CITY OF ALBUQUERQUE

RE: **Homewood Suites - 5400 San Antonio Dr. NE**
Grading and Drainage Plan
Engineer's Stamp Date 2/xx/2018
Hydrology File: E18D050

Based on the information provided in the submittal received on 2/20/17 the above-referenced Grading Plan cannot be approved for Building Permit until the following comments are addressed.

GRADING PLAN

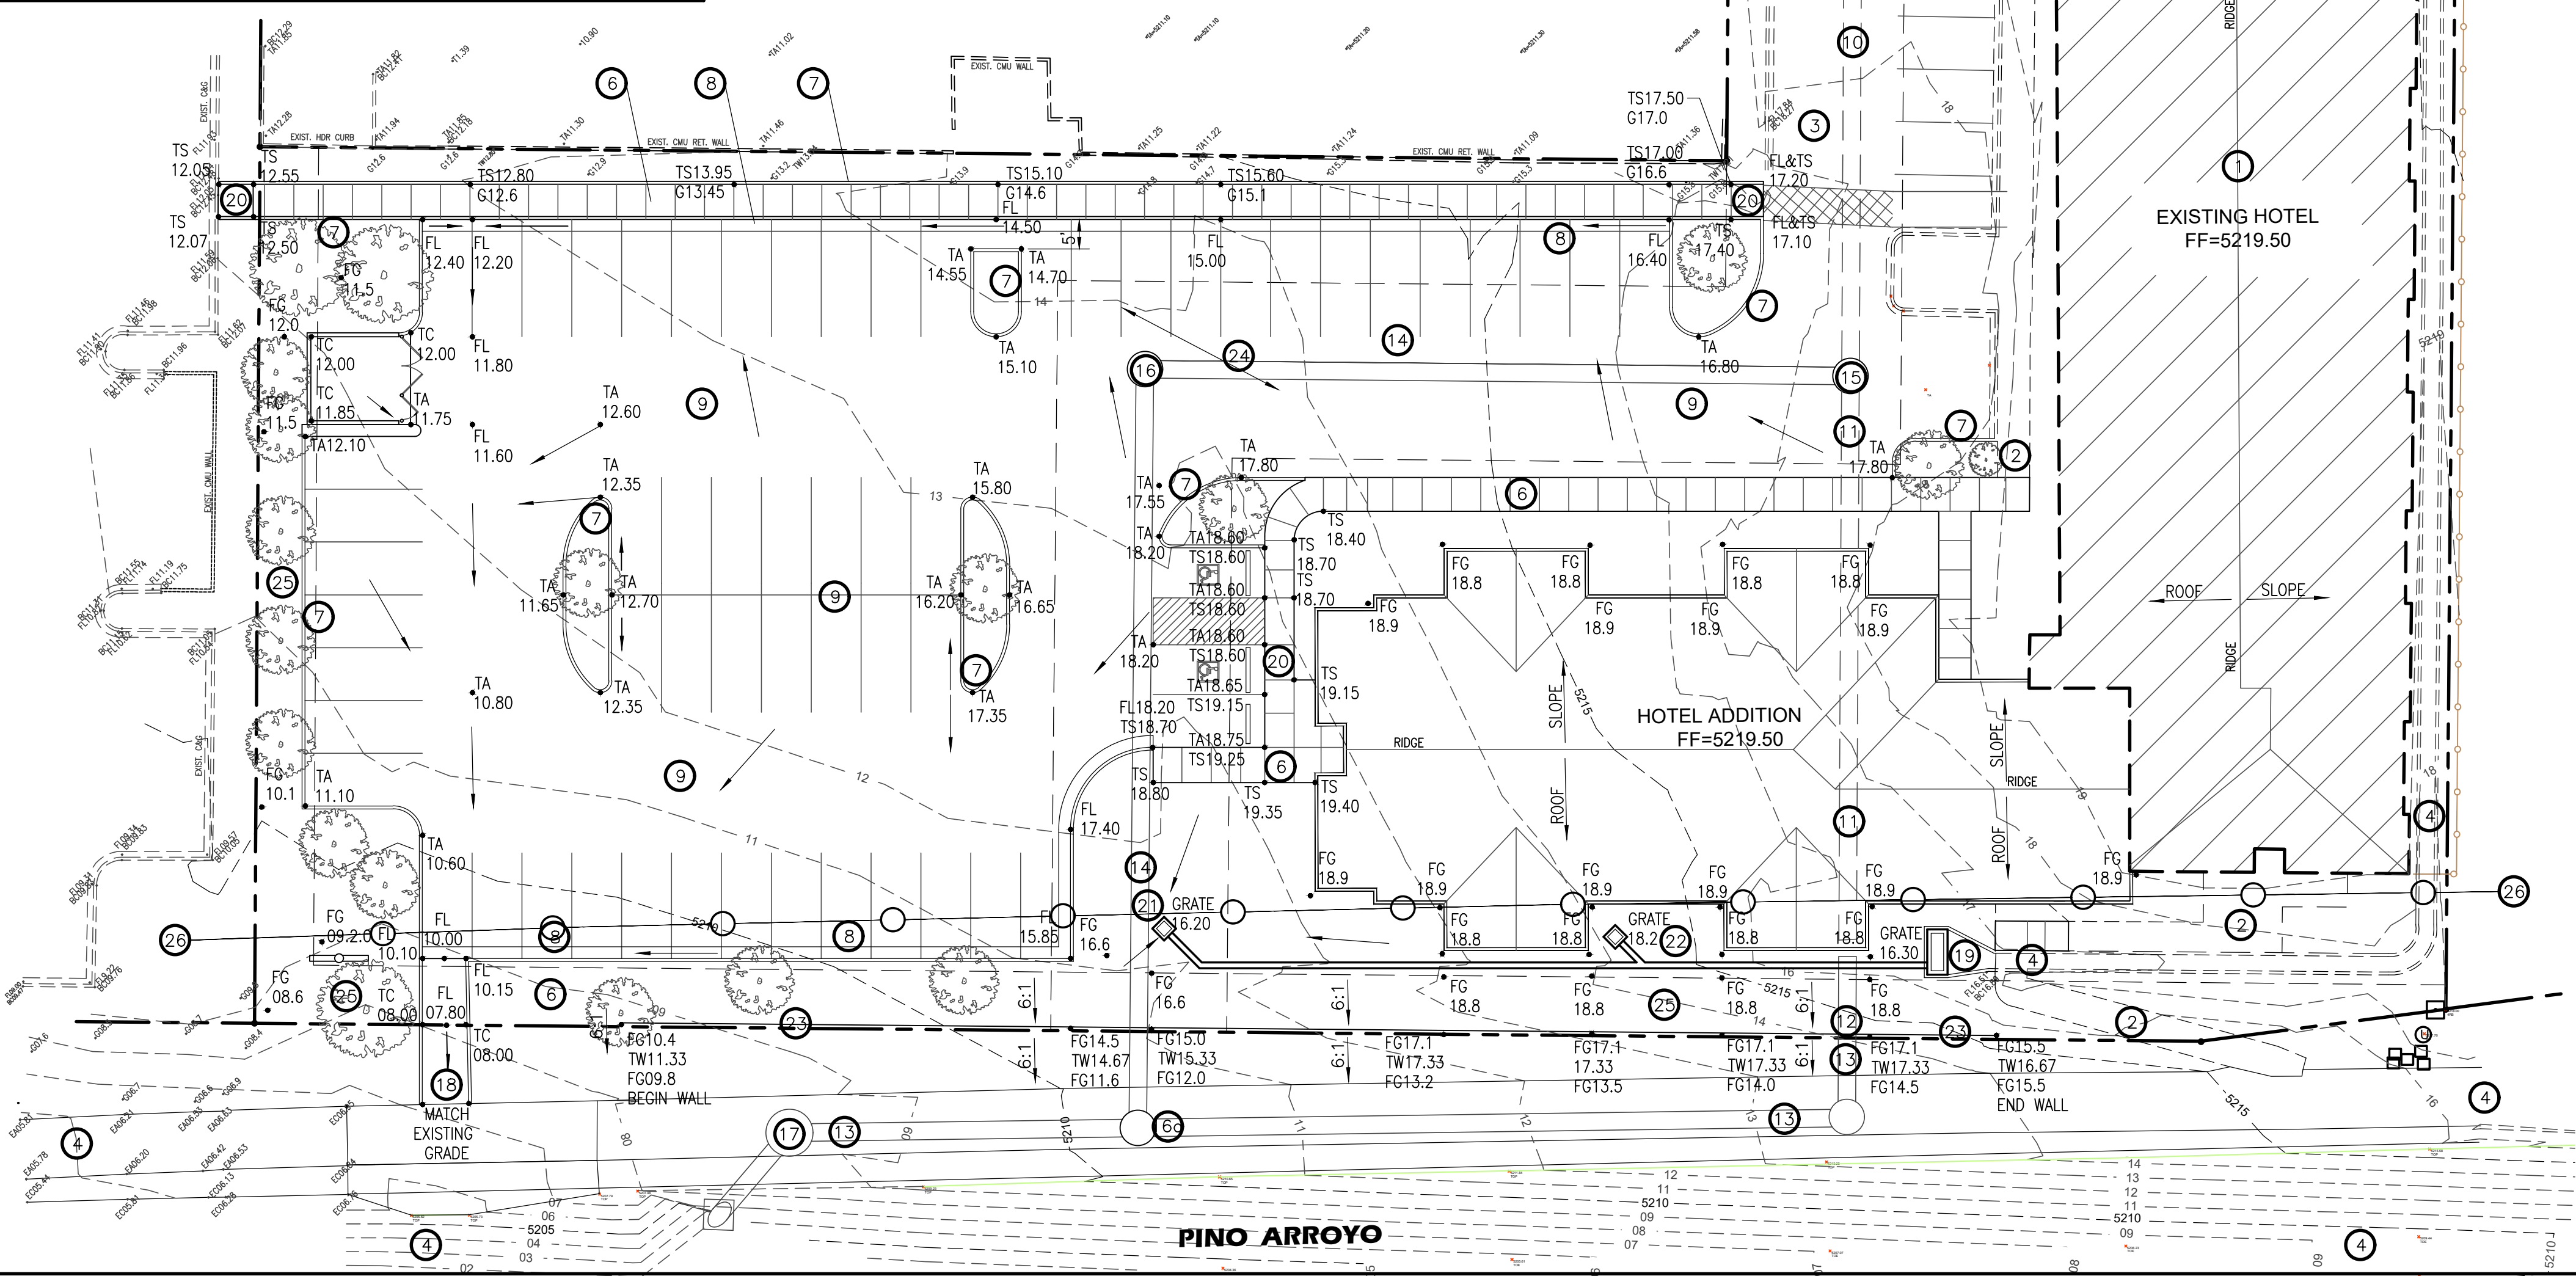
3. Grading Plan approval is also required for Building Permit Approval and Work Order Approval, and should be so checked on the DTIS form.
4. The location of the temporary bridge & north abutment must also be shown on the G&D Plan.

5. Notes are to be added to the G&D Plan and the DRC P&P stating that "The existing Public Storm Drain thru this site must remain functional at all times. Temporary diversion ditches will be constructed and maintained when the storm drain is not in service".

7. Profiles of the public pipes should show Q, V, and HGL. They were missing from the revised G&D submittal.
8. Private maintenance will be required for the piece of pipe that will be left in the Channel Right of way that will just receive private drainage. An Agreement and Covenant will be required prior to DRC approval, and the recording information

10. The new easement must be labeled on the G&D plan with recording information.
11. Keynote # 4 is used to label both the public channel south of the site and the private channel south and east of the existing building. Public must be differentiated from private.

12. Keynote # 17 needs to be changed to "Existing MH to remain"
13. Remove Keynote #13 next to the existing MH at Keynote #17 because that piece of existing pipe will remain public.

14. Keynote #24 does not point to anything on the drawing. The existing easement must be shown, and the note should say "To be vacated at a later date".

15. Typical sections must be added on the G&D Plan thru the edges of the site showing existing and proposed grade, existing and proposed improvements, the property line, and maximum and minimum dimensions both vertical and horizontal. Particular attention must be given to grading (either cut or fill) near property lines. Per DPM 22.5.B, "Care should be taken to ensure that existing foundations, retaining walls, stable slopes or other structures are not endangered and that the adjacent property is not damaged or its use constrained due to grading at or near the property line".

- e. Landfill Mitigation Plan & Permit.
21. A sheet should be added to the G&D Plan showing the entire area of disturbance associated with this project including the staging area south of the South Pino Arroyo. The sheet should include a line indicating the limits of disturbance, a note identifying the area of disturbance, and a note requiring stabilization of all disturbed areas prior to Certificate of Occupancy.

22. The "Grading" and "Erosion Control" notes are on sheet C1.1 in two different places. Delete one of the sets of notes.
23. A separate Erosion Control Plan must be submitted to the Storm Water Quality Section on the fourth floor prior to G&D Plan approval. The Plan must be approved prior to inclusion in the DRC plans.
